SERVICE BULLETIN

APPLICABILITY: 2015-20MY Legacy and Outback
 2012-19MY Impreza
 2013-19MY Crosstrek
 2013-19MY Forester
 2015-20MY WRX and STI
 2019-20MY Ascent

NUMBER: 12-203-16R

SUBJECT: Squeaking Sound from Front Seat Buckle

OLD Wave Washer

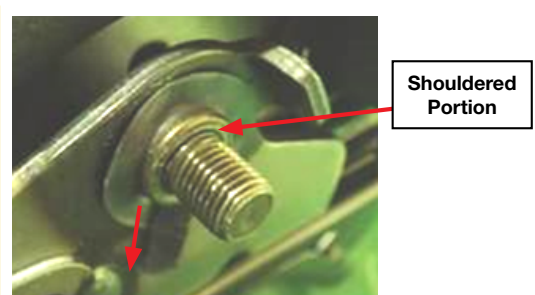
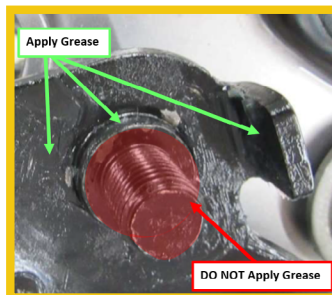
The 3 “tang” seen on the inside of the **OLD** wave washer have been deleted. The new washer also has a goldish-color flurocarbon resin coating. The inside diameter of the **NEW** spring wave washer has been decreased and a small felt added to allow the washer to turn smoother with the buckle and have a better fit on the shoulder portion of the retaining bolt.

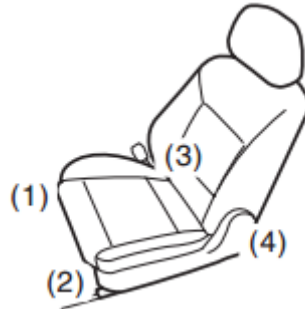
- Install the new spring wave washer onto the groove in the shouldered portion of the mounting bolt as shown below. The felt portion should be at about the 6:00 position (pointing down).
